Access Compliance Report

Public Rights-of-Way

(Curb Ramps)

Intersection ID: 15195	Main Street: ALBEMARLE_RD	Cross Street: FARM_POND_LN	Location:	N
ADA ID: A21B533D8C1B	Ramp Type: MedianPerp	Initial Pass/Fail: Fail	Overall Compliance: No	Severity Score: 8.75
Codes/Mitigation Info/Possible Solution		Field Measurements/Component Compliance

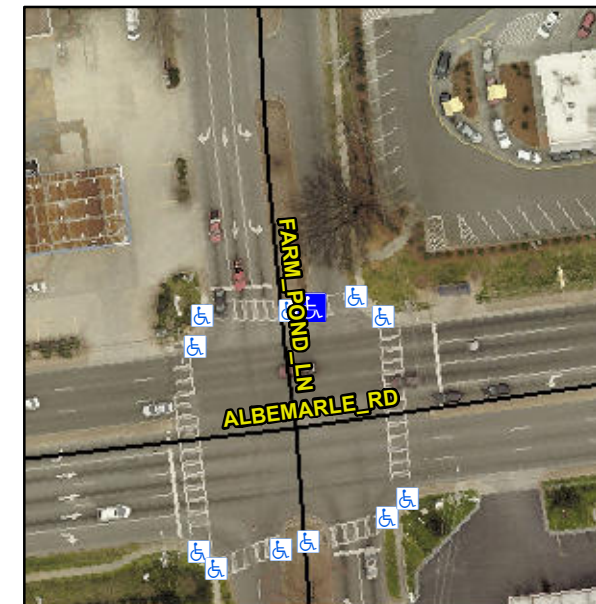
Not Found, R304.5.1

Compliance	Description	Data	Compliance	Description	Data
N/A	Ramp Length (in)	53.0	Yes	Ramp Slope (%)	6.4
No	Ramp Width (in)	41.0	Yes	Ramp XSlope (%)	1.8
N/A	Flare Type LT	N/A	N/A	Flare Type RT	N/A
N/A	Flare Slope LT (%)	N/A	N/A	Flare Slope RT (%)	N/A
N/A	Flare Traversable LT?	N/A	N/A	Flare Traversable RT?	N/A
N/A	Landing Length (in)	N/A	N/A	DWS Provided?	N/A
N/A	Landing Width (in)	N/A	N/A	DWS Contrast?	N/A
N/A	Landing Slope (%)	N/A	N/A	DWS Length (in)	N/A
N/A	Landing X Slope (%)	N/A	N/A	DWS Full Width?	N/A
N/A	Landing Curb? (Y/N)	N/A	N/A	DWS Offset (in)	N/A
N/A	Shared Landing?	N/A			
N/A	Gutter Ponding?	N/A	N/A	Gutter Slope (%)	N/A
N/A	Gutter Lip Ht (in)	N/A	N/A	Gutter X Slope (%)	N/A
N/A	Painted X Walk1?	Yes	N/A	Painted X Walk2?	N/A
	X Walk 1 Direction	To E		X Walk 2 Direction	N/A
N/A	X Walk 1 Width (in)	110.0	N/A	X Walk 2 Width (in)	N/A
	X Walk 1 Slope (%)	2.5		X Walk 2 Slope (%)	N/A
	X Walk 1 X Slope (%)	2.0		X Walk 2 X Slope (%)	N/A

Remove & Replace Entire Ramp.
